RE: **Application for Development Review & Design Review
Crossroads Industrial – Parcel ID 2325-122-0002-000-3**

STAFF REPORT

SUBJECT: Crossroads Industrial – 2325-122-0002-000-3
TECHNICAL REVIEW PROJECT: # 20-07000018

**RE : Crossroads Industrial Site Plan
TRC No. 20-07000018**

CROSSROADS COMMERCE PARK
 SECTION 25, TOWNSHIP 35S., RANGE 39E.
 CITY OF FORT PIERCE, FLORIDA
 CONCEPTUAL PAVING, DRAINAGE,
 WATER AND WASTEWATER PLAN

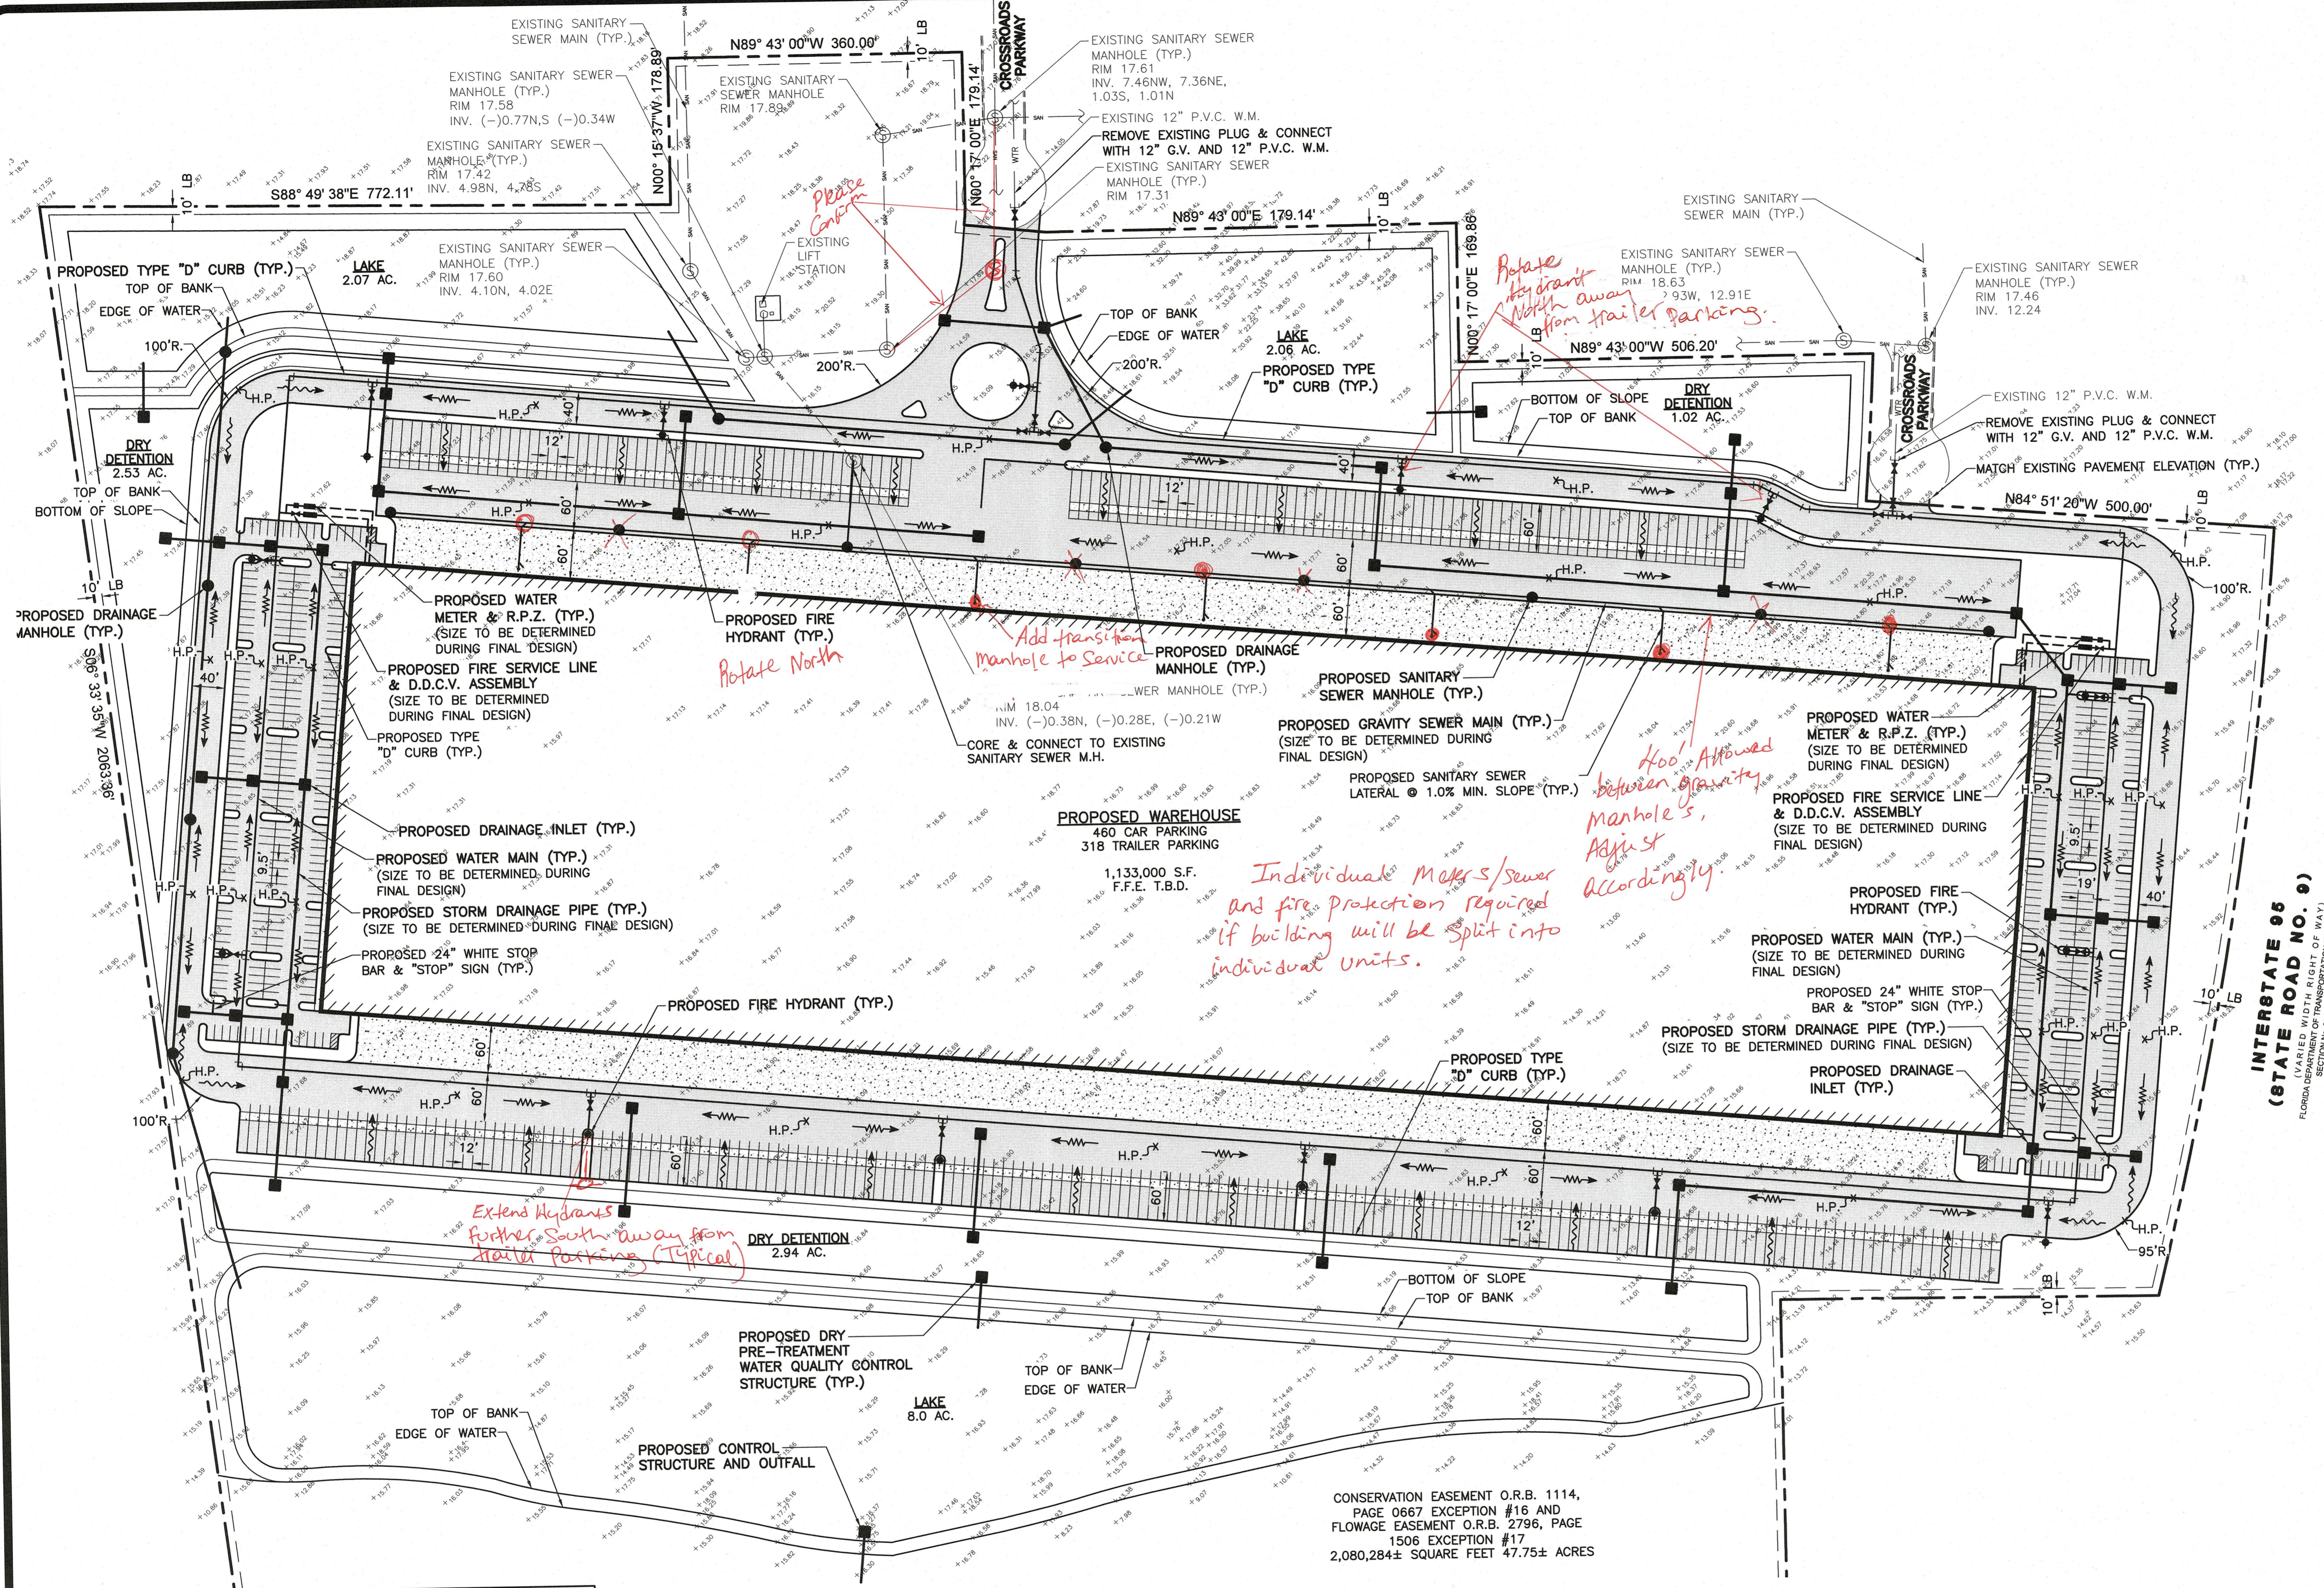
2. The conceptual drainage plan reflects different lake sizes and locations from what is shown on the site plan; please revise the plans accordingly so the two plans have the same base layout.

3. The drainage plan indicates a dry detention area proposed to be located adjacent to the eastern Crossroads Parkway; please relocate this detention area to comply with the requirements specified in the City of Fort Pierce Code of Ordinances Section 119-9(c)(1) or revise the system to a wet retention/detention system and comply with the specifications noted in Section 1190(c)(2).

5. **ADVISORY COMMENT:** The final drainage plan will be required to compensate for the conveyance of any off-site drainage flows currently routed through the site from the north.
